Access Compliance Report

Public Rights-of-Way

(Curb Ramps)

Intersection ID: 47454	Main Street: WOOD_DUCK_CROSSING_DR	Cross Street: WINGED_TEAL_RD	Location: NW
ADA ID: 28C61293F1C7	Ramp Type: PerpDiag	Initial Pass/Fail: Fail	Overall Compliance: No
Severity Score: 10			
Codes/Mitigation Info/Possible Solution		Field Measurements/Component Compliance

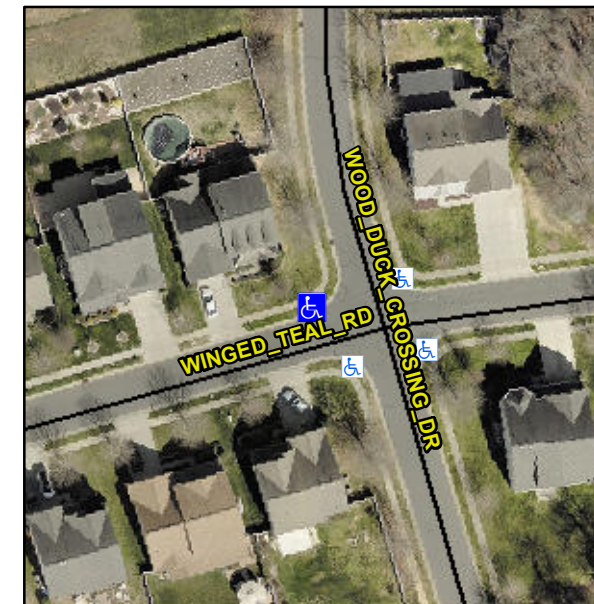
Not Found, R304.5.1, R304.5.3

Compliance	Description	Data	Compliance	Description	Data
N/A	Ramp Length (in)	45.5	Yes	Ramp Slope (%)	6.6
No	Ramp Width (in)	46.0	No	Ramp XSlope (%)	3.1
N/A	Flare Type LT	N/A	N/A	Flare Type RT	N/A
N/A	Flare Slope LT (%)	N/A	N/A	Flare Slope RT (%)	N/A
N/A	Flare Traversable LT?	N/A	N/A	Flare Traversable RT?	N/A
N/A	Landing Length (in)	N/A	N/A	DWS Provided?	N/A
N/A	Landing Width (in)	N/A	N/A	DWS Contrast?	N/A
N/A	Landing Slope (%)	N/A	N/A	DWS Length (in)	N/A
N/A	Landing X Slope (%)	N/A	N/A	DWS Full Width?	N/A
N/A	Landing Curb? (Y/N)	N/A	N/A	DWS Offset (in)	N/A
N/A	Shared Landing?	N/A			
N/A	Gutter Ponding?	N/A	N/A	Gutter Slope (%)	N/A
N/A	Gutter Lip Ht (in)	N/A	N/A	Gutter X Slope (%)	N/A
N/A	Painted X Walk1?	No	N/A	Painted X Walk2?	No
	X Walk 1 Direction	To S		X Walk 2 Direction	To E
N/A	X Walk 1 Width (in)	N/A	N/A	X Walk 2 Width (in)	N/A
	X Walk 1 Slope (%)	0.8		X Walk 2 Slope (%)	4.2
	X Walk 1 X Slope (%)	3.8		X Walk 2 X Slope (%)	1.2

Remove & Replace Curb Ramp With Two New Directional Ramps or Equivalent.
